1 Products affected

Ground terminal assembled with a clamping plate.

4790					0118.2304	
creation date	created by	release date	released by	notification no.	revision	page
2015-09-02	bisanger	2015-09-30	bisanger	27929	-	1 of 2

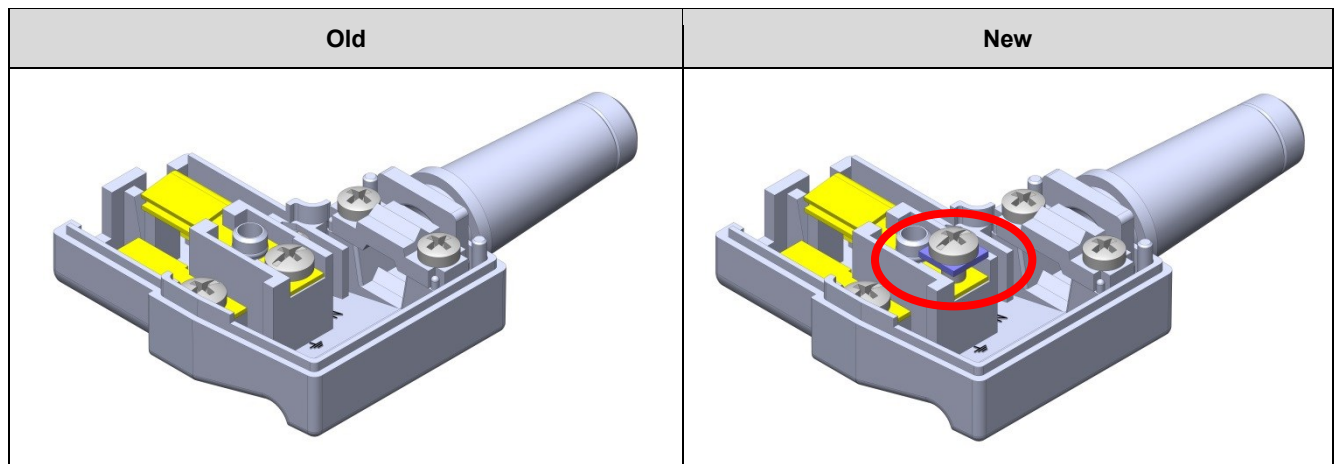
The terminal screw "Ground" is pre-assembled with a clamping plate, which will retain all individual wires below the screw head (blue part in picture below).

An uncareful wire insertion could lead to unsatisfactory screw connection. The clamping plate makes the handling easier and the screw connection more safe.

Form:	No	There are no form changes
Fit:	Yes	Screw terminal "Ground" assembled with a clamping plate
Function:	No	This is a non-functional change
Production Site:	No	There is no change of the production site
Product Label:	No	There is no change on the label
